# CITY OF PORTLAND, MAINE

March 17, 2015

**Project Name:** Midtown  
**Project ID:** #2014-203  
**Address:** 59 Somerset Street  
**CBL:** 34-B-2, 3, 4, 5, 22 and 34-D-3, 9, 10  
**Applicant:** FEDEQ DV001, LLC.  
**Planner:** Richard Knowland

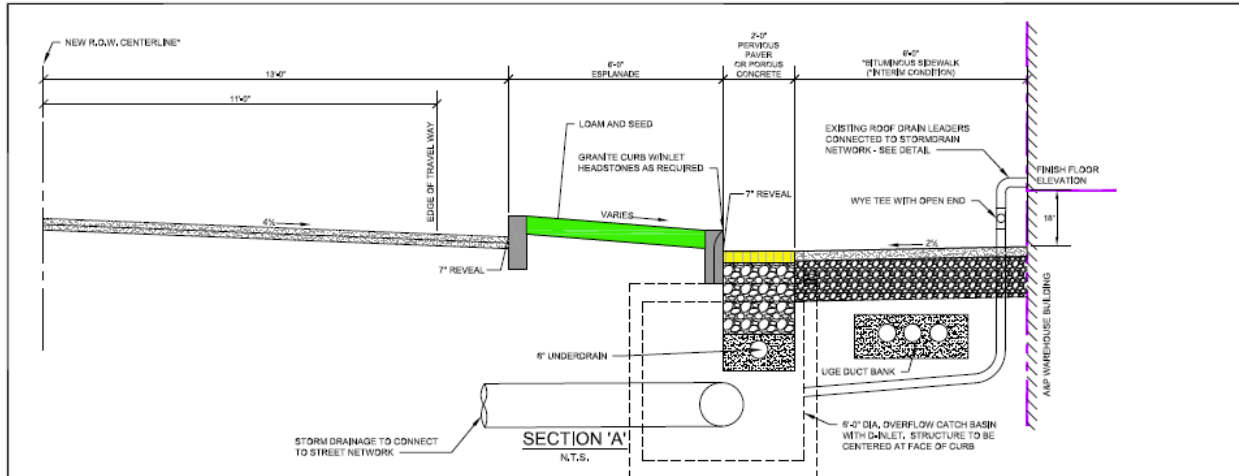
The FST design required certain waivers in street design standards (between Chestnut and Elm) to address this concern but the City was not comfortable supporting these waivers during the initial review. Although the Pearl to Chestnut street design was approved by the Board, the Chestnut to Elm section was left as a condition of approval.

Subsequently the Department of Public Services met with Planning staff and development review consultants to discuss street design waivers for the street adjacent to the Noyes building. These discussions concluded the City could support certain design exceptions (waivers) for the Somerset Street cross section between Chestnut and Elm as stated below:

- Curb reveal of 6 inch (minimum) in lieu of City Standard of 7 inches. Note: Curb reveal should be the same height along entire block and on both sides of street to aid in future pavement milling and/or overlay projects.

- Sidewalk cross slope of 0.5% minimum in certain unique locations and 2% maximum in lieu of City Standard of 2%; okay for certain areas to exceed 2% cross slope (up to 4% max) so long as there is 5 feet wide accessible route with 2 % maximum cross slope at that location.

Midtown Three Typical Floor Plans

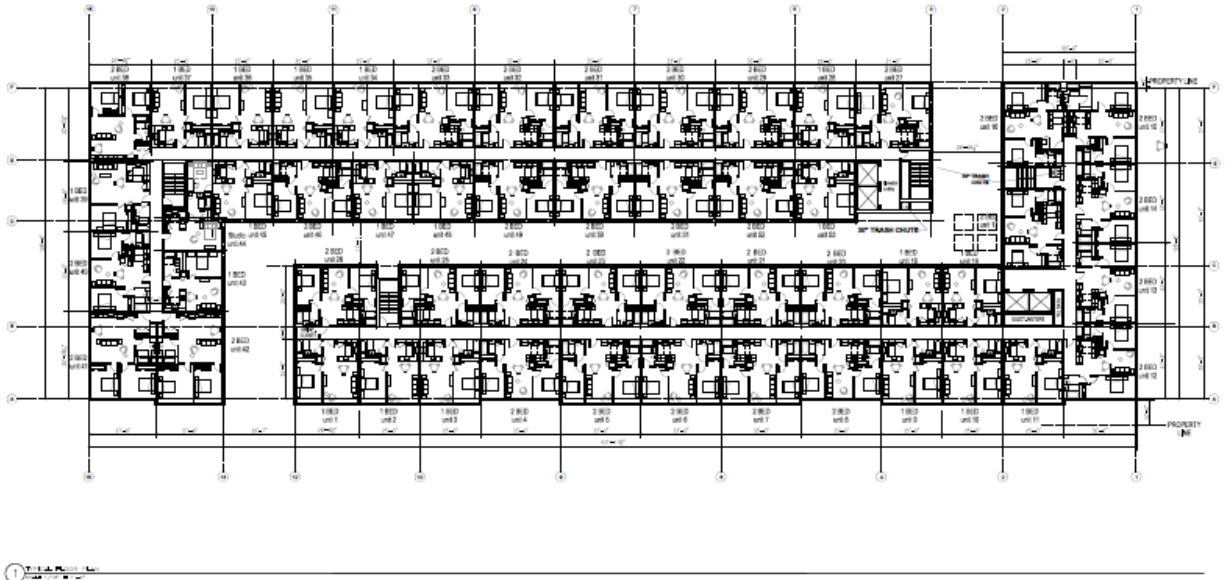
**Comment:** This standard mirrors to some extent the requirements of the B-7 Design Standards, specifically the Purpose Statement #4 and Standard A-1, which reference “access to light and air”. Midtown One and Four are designed with all units facing exterior views with ample sunlight and air. Midtown Three is comprised of

two long (346' x 55') 'L'-shaped buildings above the retail first floor, (see floor plan below) Subject to verification with the architects, we understand that each dwelling has a sufficient amount of windows. The Department's position is that Midtown Three meets this standard for sunlight and air.
